APPEAL SUMMARY

Appeal ID: 27924	Project Address: 716 SE Grand Ave
Hearing Date: 8/3/22	Appellant Name: Tom Jaleski
Case No.: B-008	Appellant Phone: 971-238-5266
Appeal Type: Building	Plans Examiner/Inspector: Steve Mortensen
Project Type: commercial	Stories: 2 Occupancy: A, B, S-1 Construction Type: III-B
Building/Business Name: Literary Arts	Fire Sprinklers: Yes - Entire Building
Appeal Involves: Reconsideration of appeal	LUR or Permit Application No.:
Plan Submitted Option: pdf [File 1] [File 2] [File 3] [File 4] [File 5] [File 6] Proposed use: Commercial

LITERARY ARTS HQ

716 SE GRAND AVE, PORTLAND, OR 97232

FLOOR PLAN - LEVEL 1

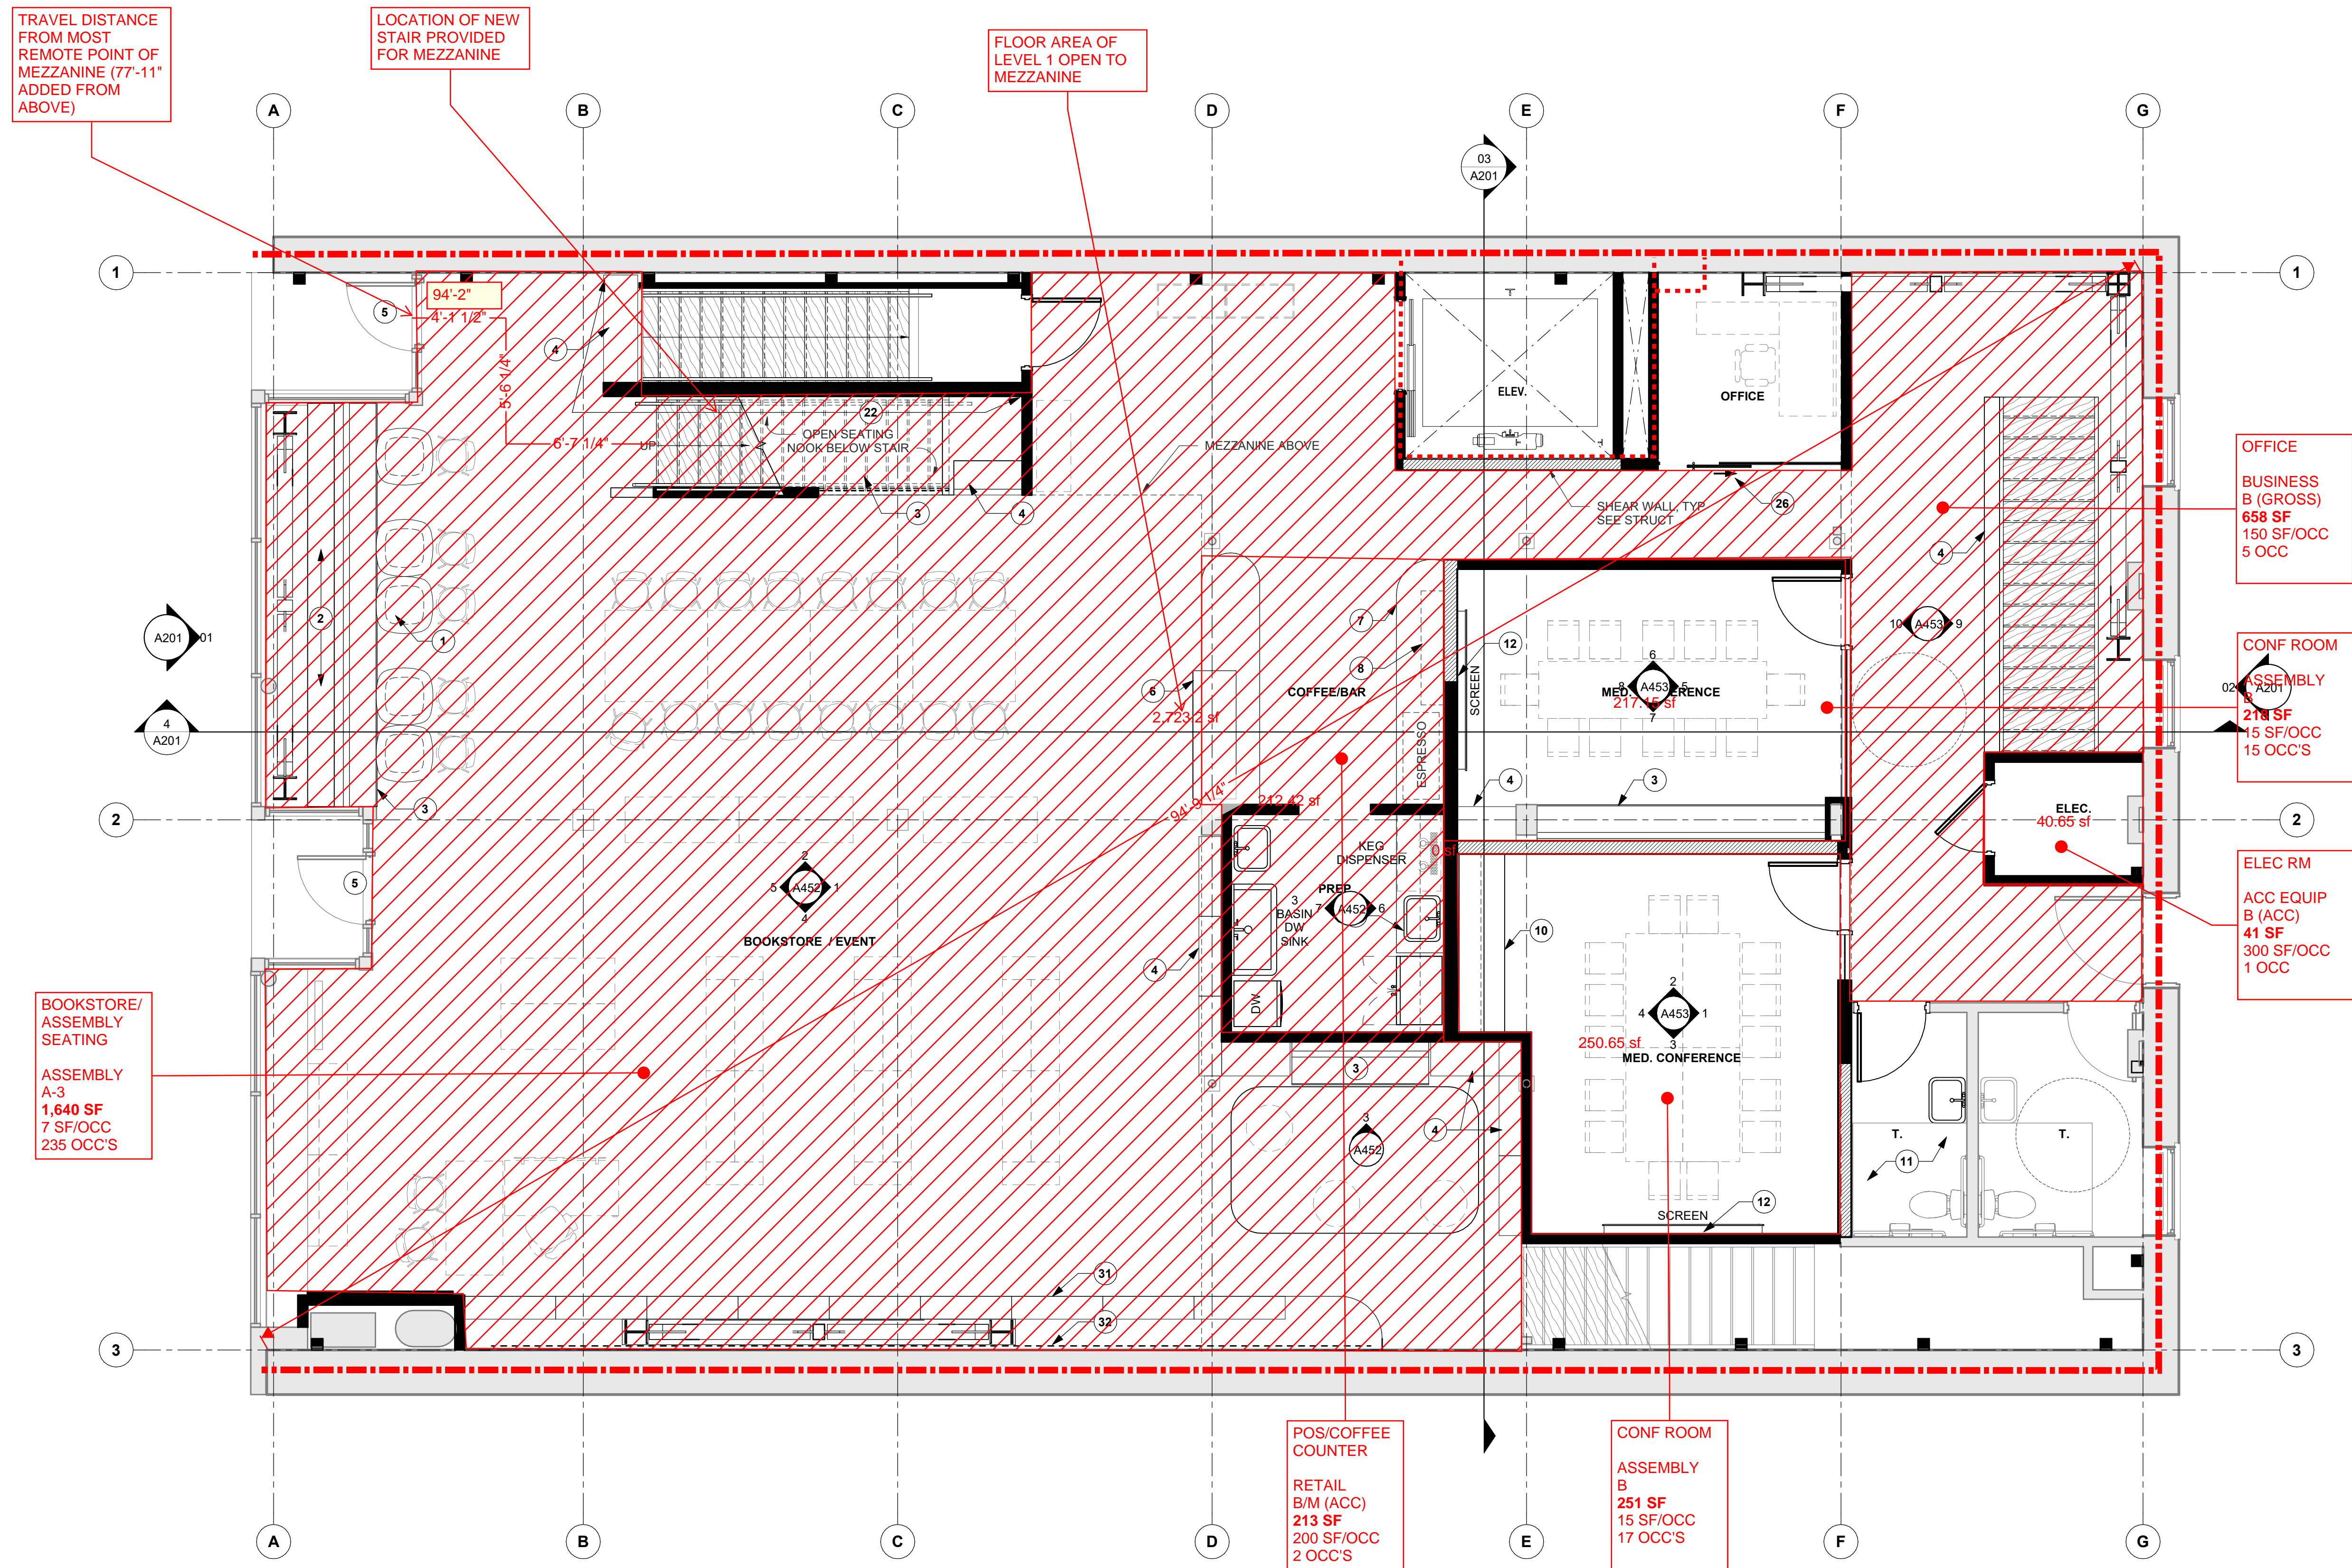
Code Section	OSSC 2902.1
Requires	<p>2902.1 Minimum Number of Fixtures</p> <p>Plumbing fixtures shall be provided in the minimum number as shown in Table 2902.1 based on the actual use of the building or space. Uses not specifically listed in Table 2902.1 shall be considered individually by the building official and shall reflect the use of the space being served by the fixtures. The number of occupants shall be determined by this code.</p> <p>Reconsideration Text</p> <p>No Change</p>
Code Modification or Alternate Requested	<p>Permit an existing building bathroom fixture count based on adoption of building wide single-user toilet facilities and lower actual user count compared to code required means of egress occupant load.</p> <p>Reconsideration Text</p> <p>No Change</p>
Proposed Design	<p>The project involves alteration of an existing historical building. Literary Arts, Inc. of Portland, Oregon, located in the historical Nathaniel West Building at 719 SE Grand Avenue in Portland, Oregon. This space was used previously as a furniture sales store and will be converted into office, storage and assembly spaces used for engagement of readers, support writings and inspire the next generation with great literature. The building is proposed to be equipped with 8 single-user water closets and 8 single-user lavatories. Based upon plumbing fixture calculations in accordance with Table 2902.1, the required plumbing fixtures totals are 11 water closets and 8</p>

lavatories. All restrooms are single-user toilet facilities in accordance with Section 2902.1.2. The first-floor entrance opens to the bookstore/event space which will serve as dual occupancy business and assembly type A-3 when functions are active. The assembly space will be concentrated (chairs only-not fixed) and have an occupant load factor of 1 occupant per 7 square feet. With the assembly occupancy, the required plumbing calculations push the minimum required plumbing fixture count higher than the existing fixture count. We request that the reduced required minimum plumbing fixture count be permitted based on the following improvements:

Reason for alternative For the day-to-day operations of Literary Arts, the building will serve ultimately as a business type occupancy. As such, the plumbing fixture calculations for the conference rooms, which push the minimum required plumbing fixture counts higher than the existing plumbing fixtures are calculated for, lead to overcalculation based on the actual occupant load. All conference rooms are sized less than 750-square feet and are more closely associated with the business type occupancy that exists as the dominant occupancy of the building. With the plumbing fixtures calculated with these rooms at one occupant per 150 square feet as business occupancies, the minimum required plumbing fixtures would be nine water closets and six lavatories. The building exceeds the minimum required lavatory count and is only deficient by a single water closet. As these plumbing

- 1. Reduction in the minimum required plumbing fixture count: Granted as proposed.**
- 2. Increase in the maximum allowable area of a mezzanine from one third to one half of the space it is open to: Granted as proposed.**
- 3. Decrease in the minimum allowable exit separation distance from 31 feet, 1 inch to 28 feet, 1 inch: Granted as proposed.**

4 DEMO FLOOR PLAN - LEVEL 01 MEZZ
1/8" = 1'-0"

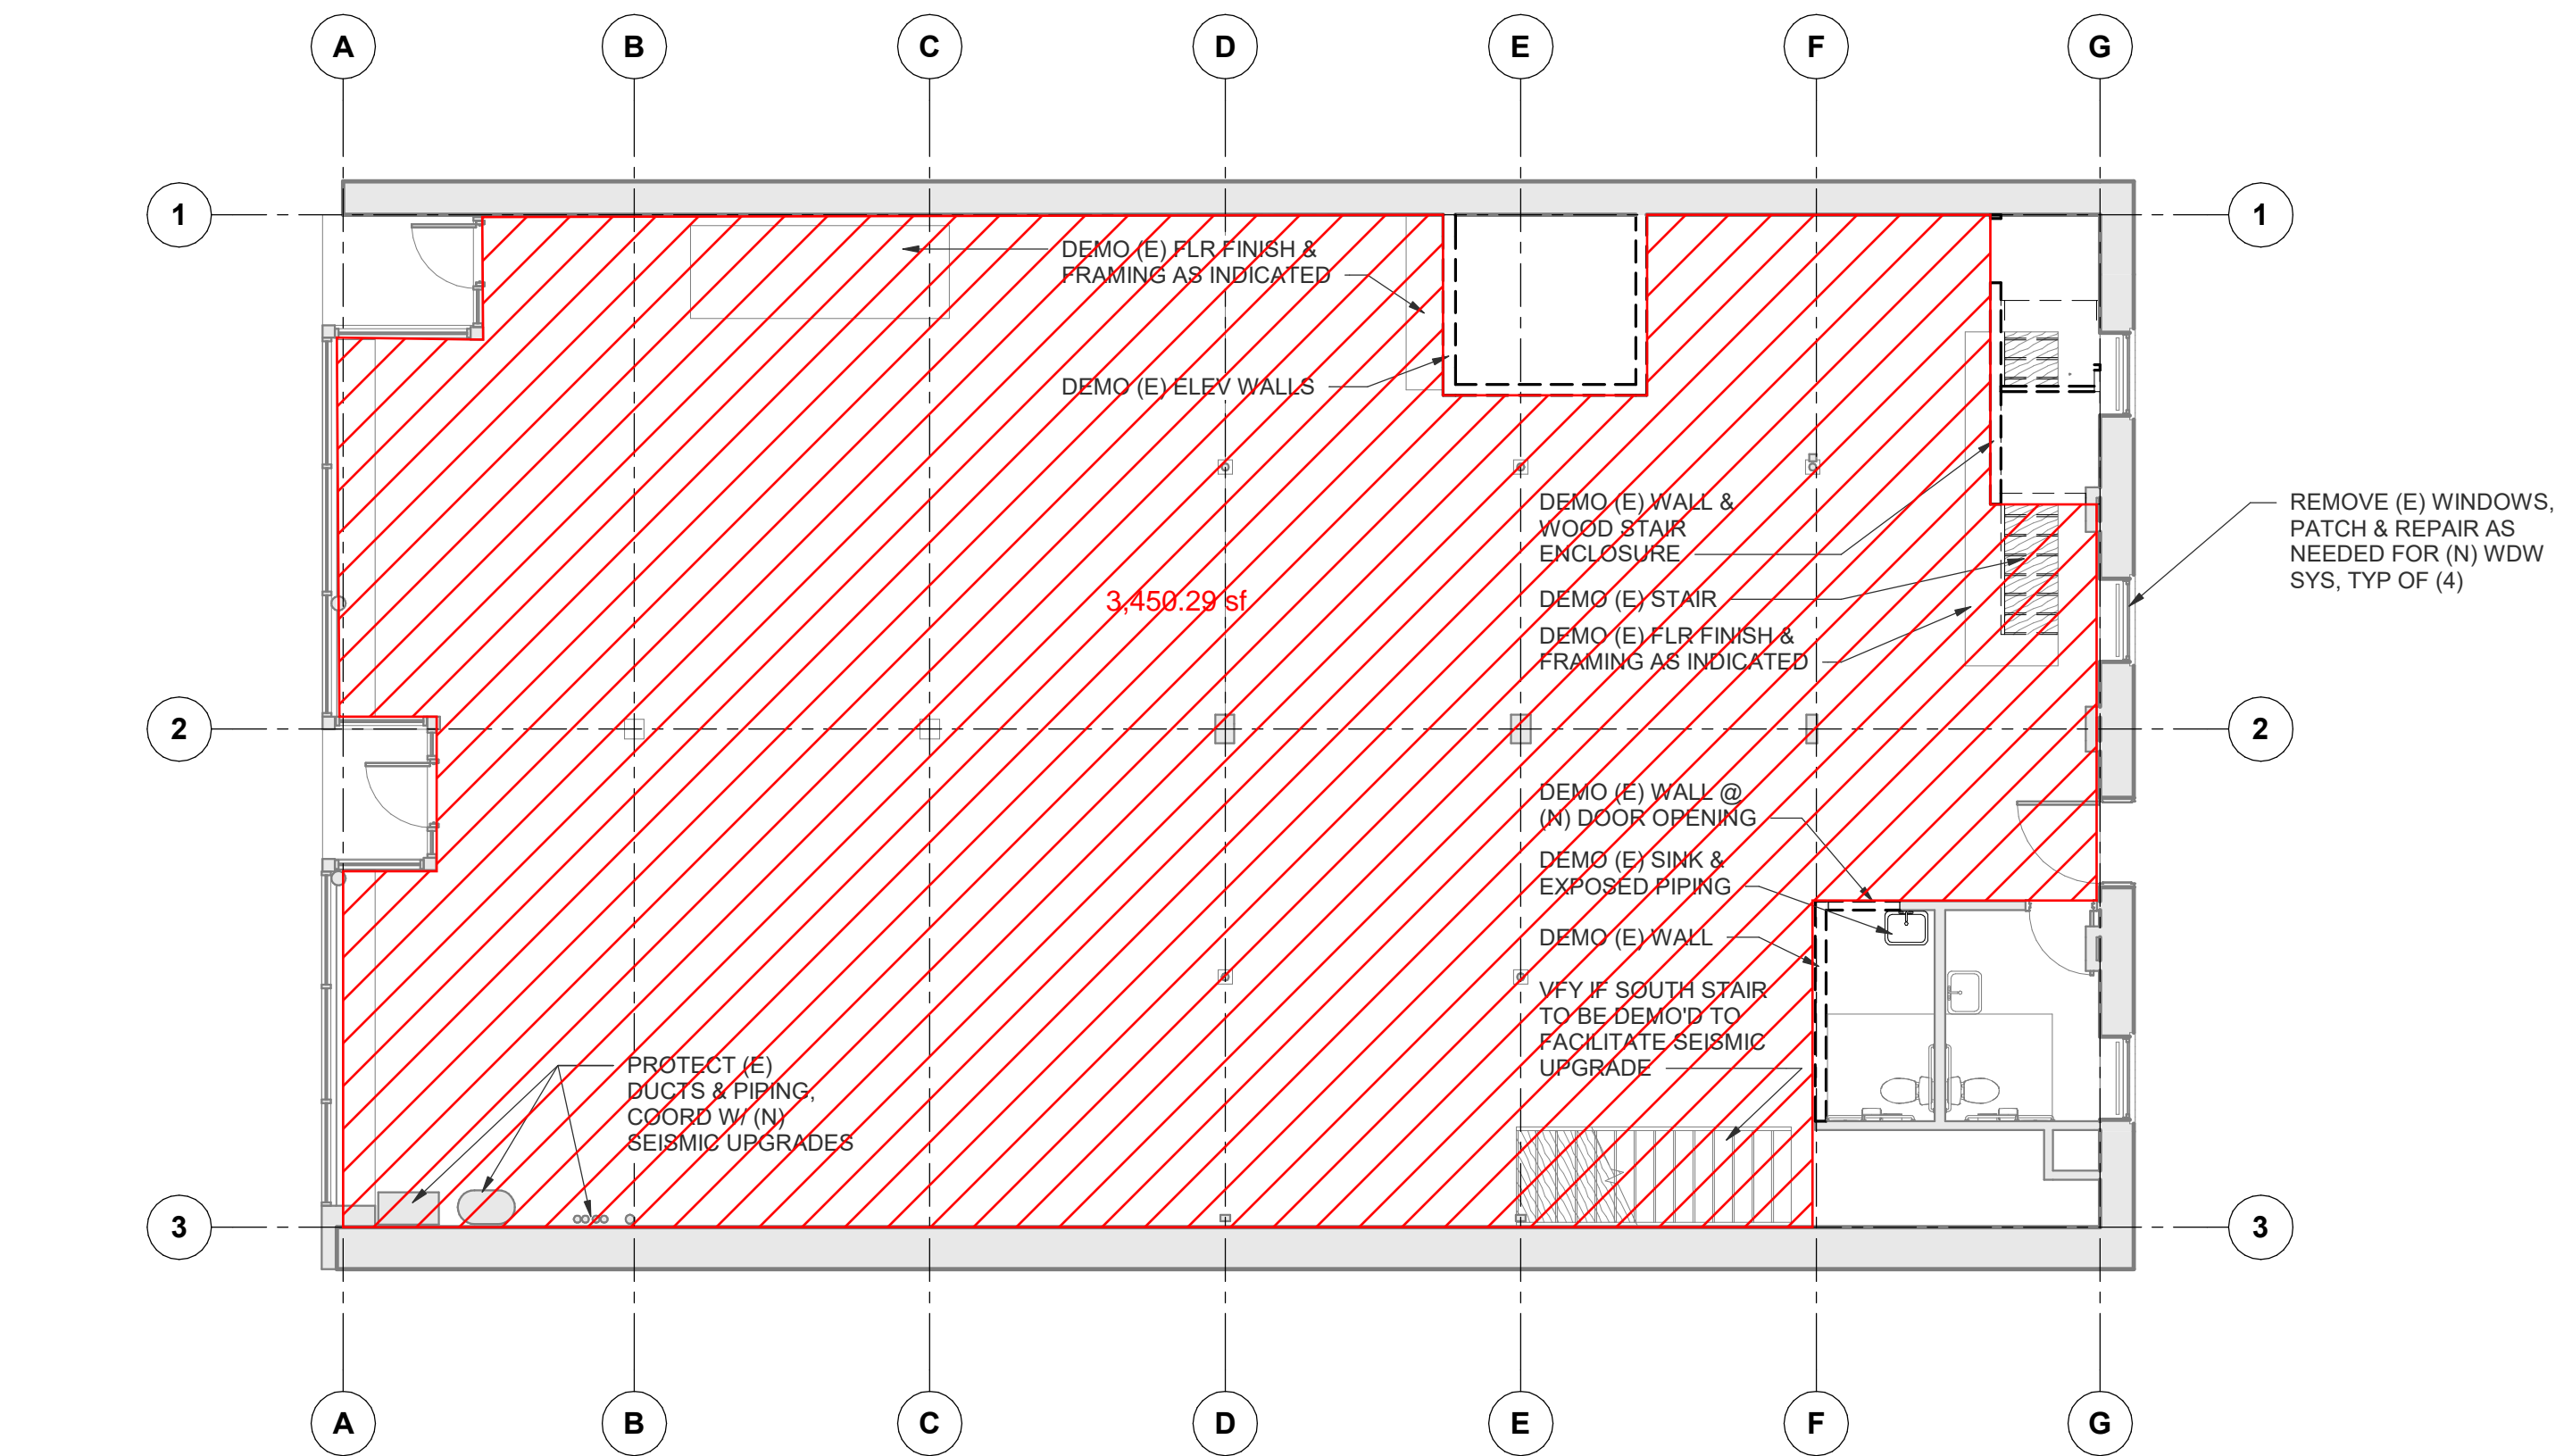
The project involves alteration of an existing historical building. Literary Arts, Inc. of Portland, Oregon, will be relocating to the historical Nathaniel West Building at 719 SE Grand Avenue in Portland, Oregon. This space was used previously as a furniture sales store and will be converted into office, storage and assembly spaces used for engagement of readers, support writings and inspire the next generation with great literature. The existing mezzanine that has been permitted under the legacy code exceeds the 1/3rd of the floor area of the room it is located in. The area of the mezzanine is 1,370 square feet while the floor area of Level 1 room that it is open to is 2,724 square feet. This exceeds one-third the floor area limit of OSSC 505.2.1. We request that this be permitted based on the following proposed improvements:

The mezzanine area as it exists today exceeds the ratio permitted by Section 505.2.1. Decreasing the floor area of the mezzanine would be a large task that would significantly reduce the usable area of the building, would be cost prohibitive, and compromise its structural integrity. The proposal will upgrade the building, while optimizing and maximizing the usefulness of the building, and improving safety and survivability of the occupants in case of a fire or other life safety event. For the following reasons this proposal will meet or exceed the code intent.
